Addendum 02

MCSD Bid No.: 2025-6
26th Street MARS/ELO-P Facility
Increments No. 1 & No. 2

Date: February 12, 2026
TETER Project No.: 23-13084

Client Project No.: Bid 2025-6
DSA Application No.: 02-123377
DSA File No.: 24-35

DRAWING TITLE: OVERALL PROPOSED SITE PLAN

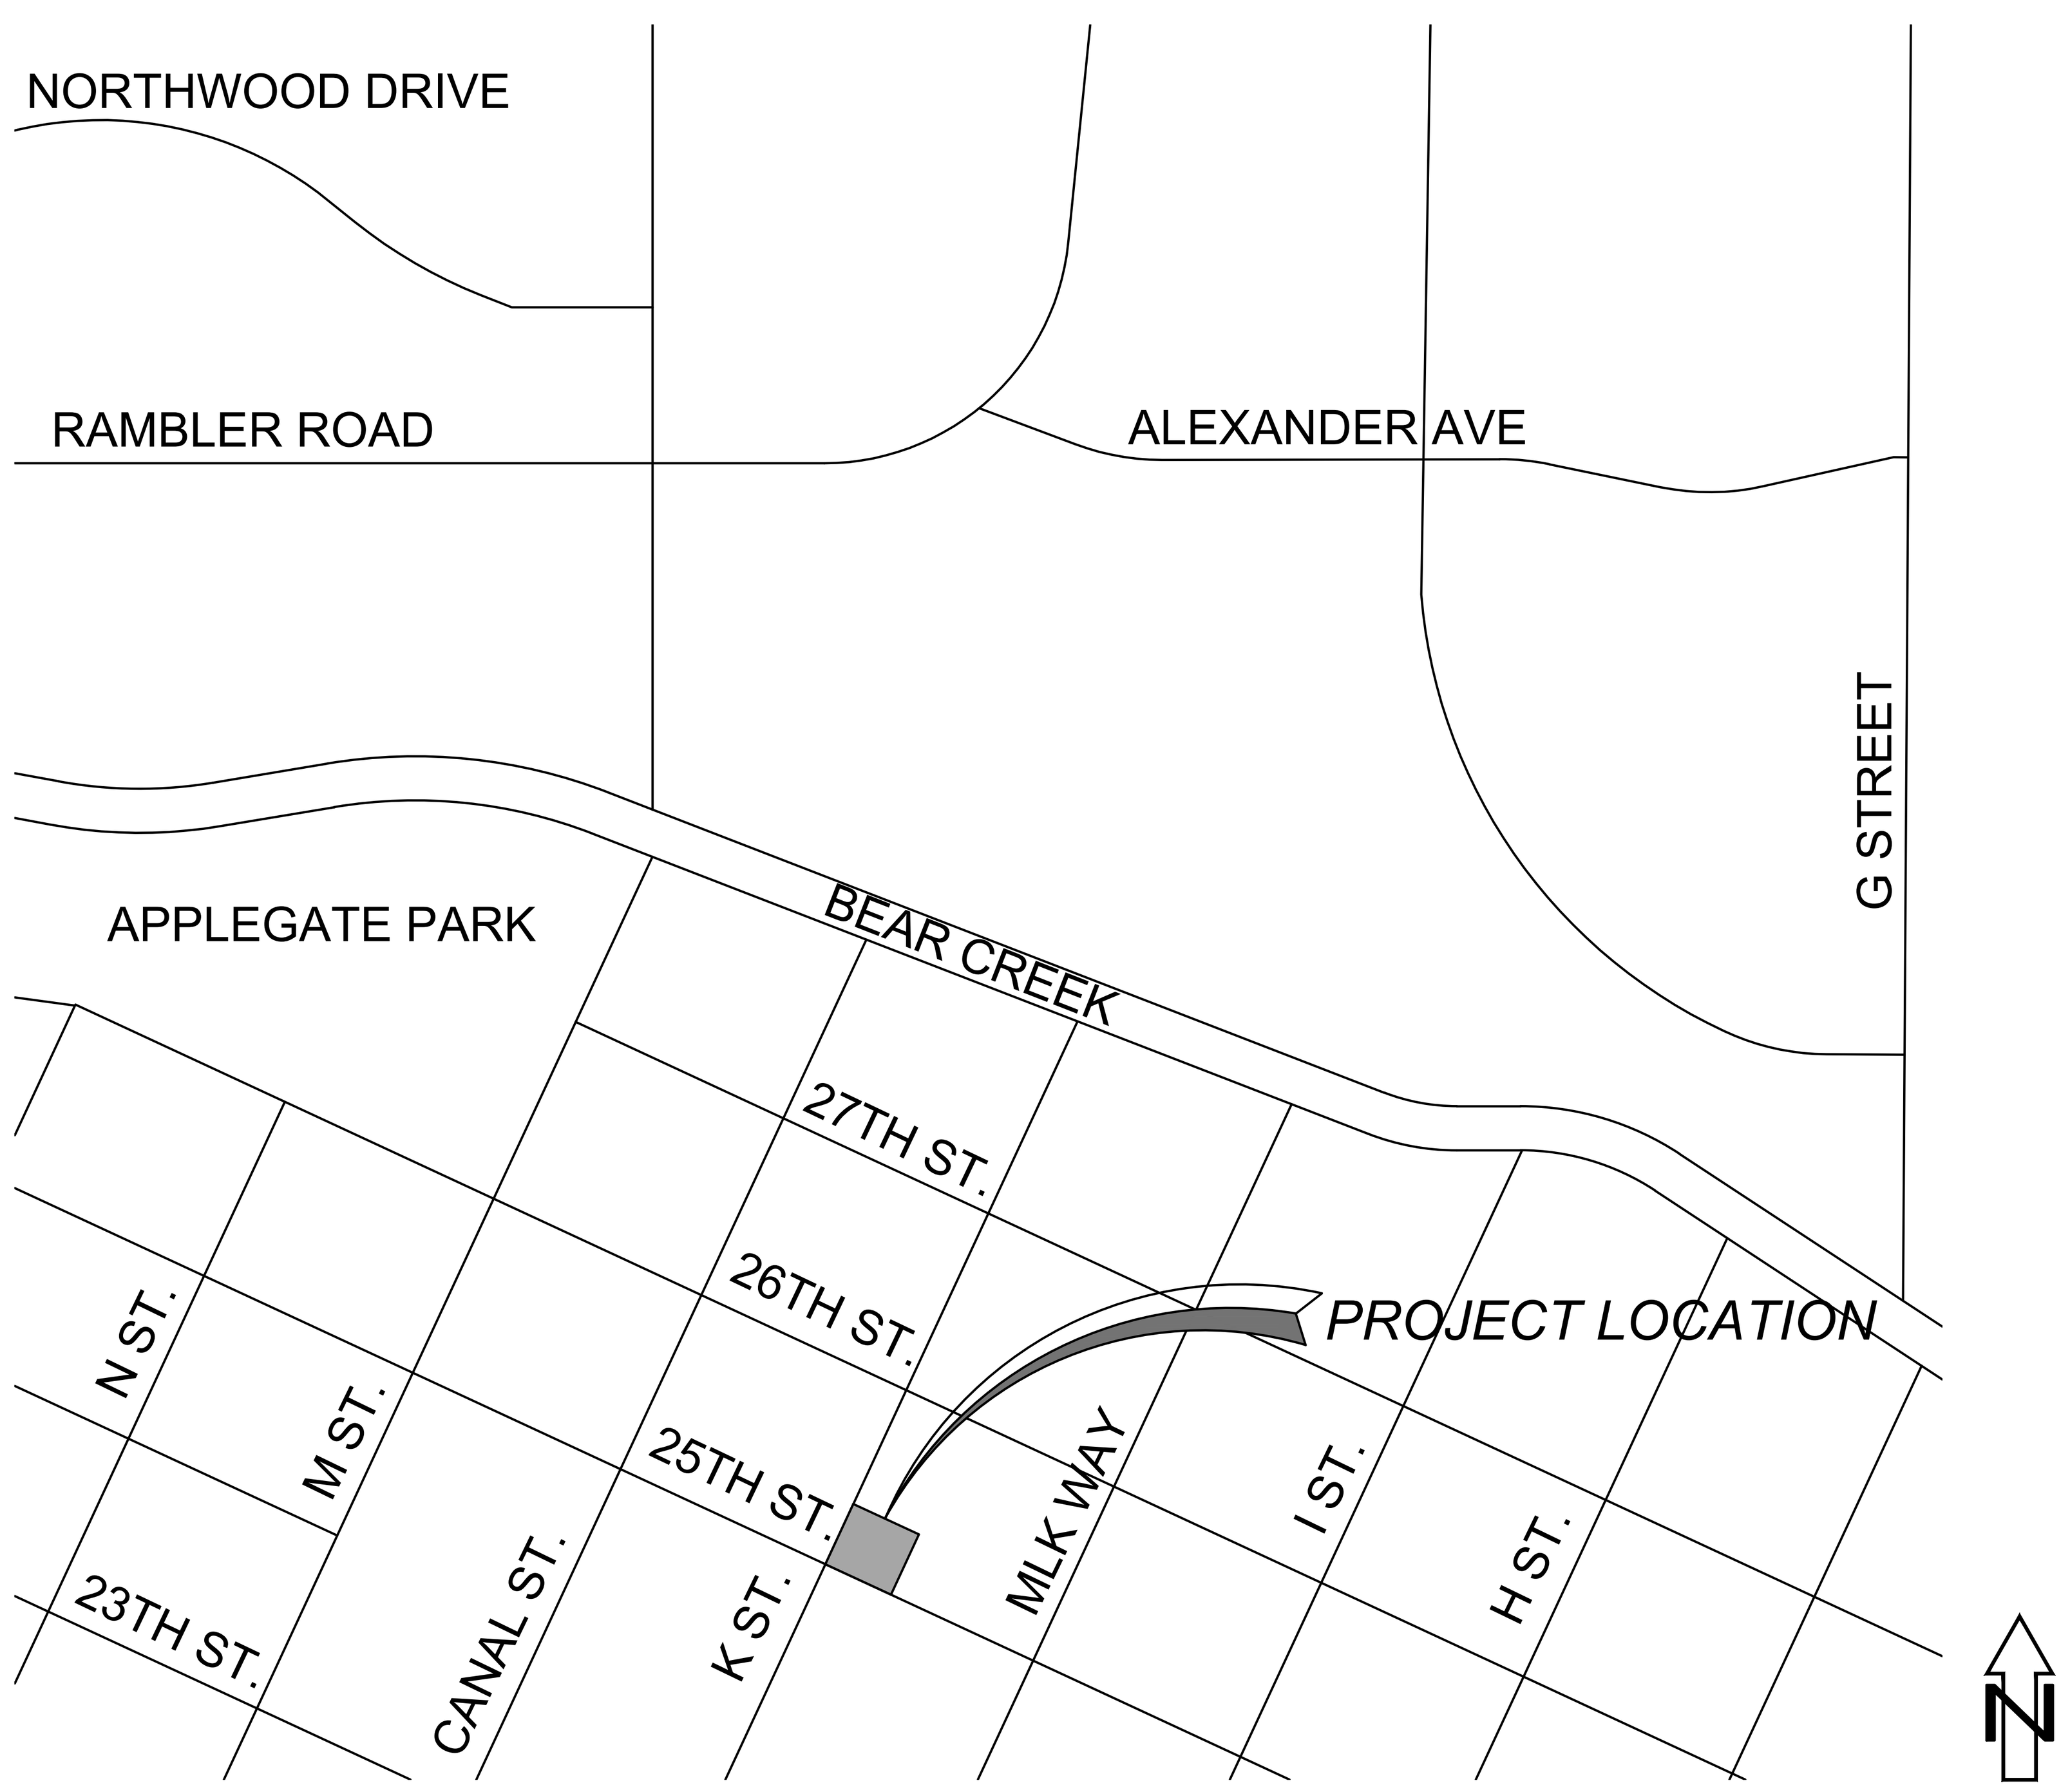
2 - 02: **A100-02 OVERALL PROPOSED SITE PLAN, PG&E GAS METER ENCLOSURE,** Merced City School District is in communication with PG&E for new electrical and gas services. Gas meter will be placed in a CMU enclosure on the southeast corner of the site. Designs are still in negotiations. A meeting with PG&E will be set once the NTP is issued. Please refer to attached sheet A100-02 for enclosure location. Please provide enclosure in your bid. (1 pages combined):

SHEET TITLE
FLOOR PLANS - MAIN BUILDING

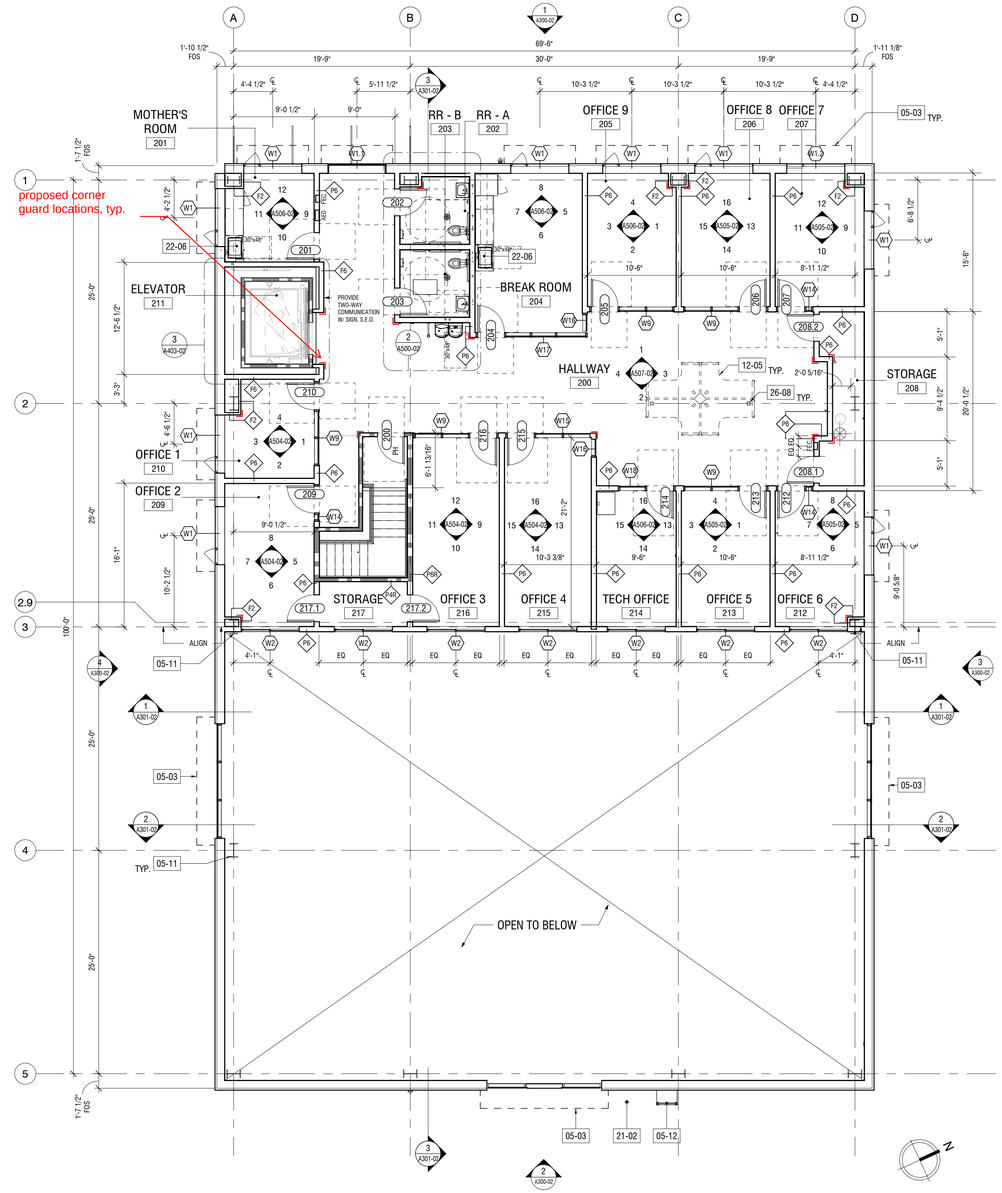
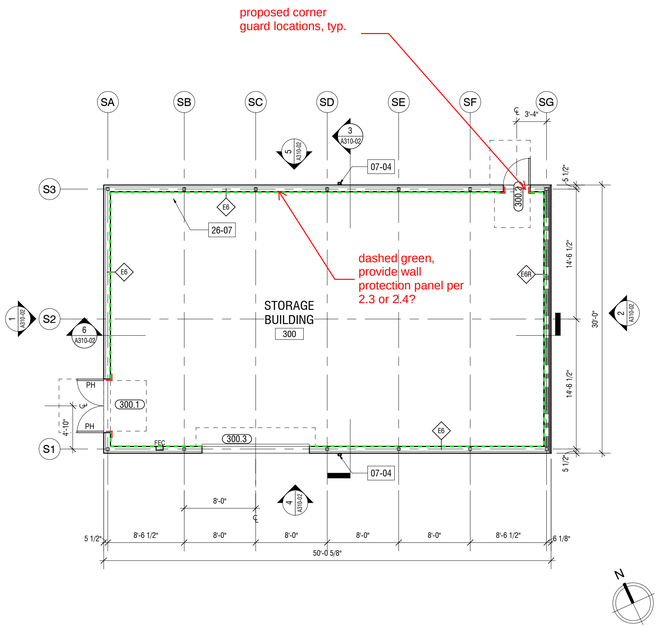
2 - 50: **RFI #48 –** 2/4/26
QUESTION: Provide details (height) and locations of the wall protection required per spec section 1026000.
RESPONSE: 48″ height per specification. Recommend at all outside corners and end walls with drywall finish. Please refer to attached marked floor plan for locations.
Attachment (2 pages)

KITCHEN - FLOOR PLAN

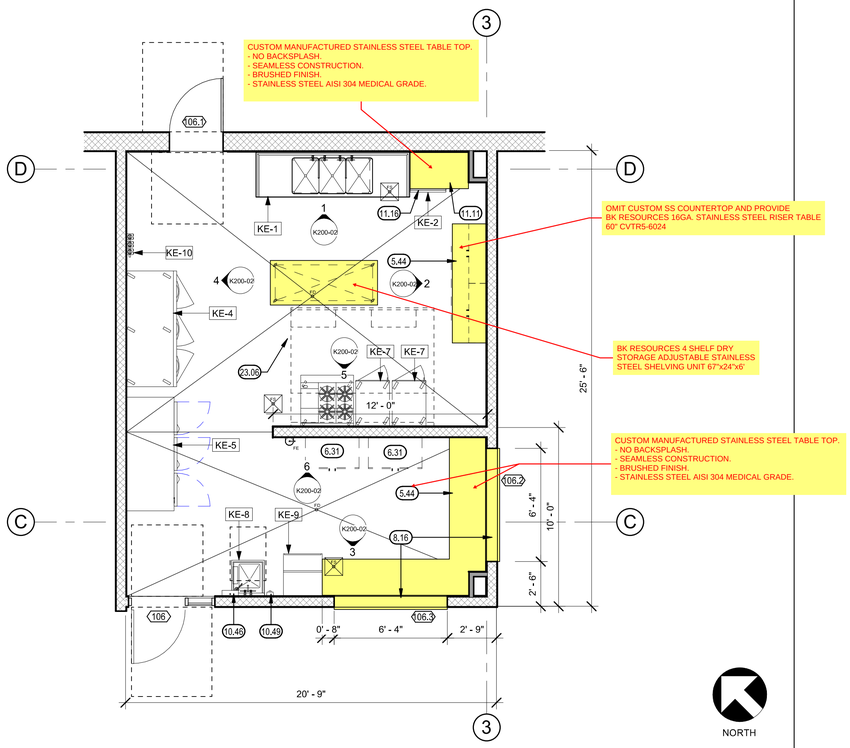
2 - 63: **RFI #61 –** 2/9/26
QUESTION: Please provide a specification for the custom stainless-steel counters.
RESPONSE: Refer to attached marked sheet K200-02 for information of (2) custom stainless steel counter tops. Omit one counter top in kitchen and replace with riser table.
Attachment (6 pages)

2 - 64: **RFI #62 –** 2/9/26
QUESTION: There is an unidentified rectangle in detail 14/k200-02, to the left of the call out "5.44". Please clarify what this is.
RESPONSE: This is a storage shelf. Refer to attached marked sheet K200-02 for product information.
Attachment (6 pages)
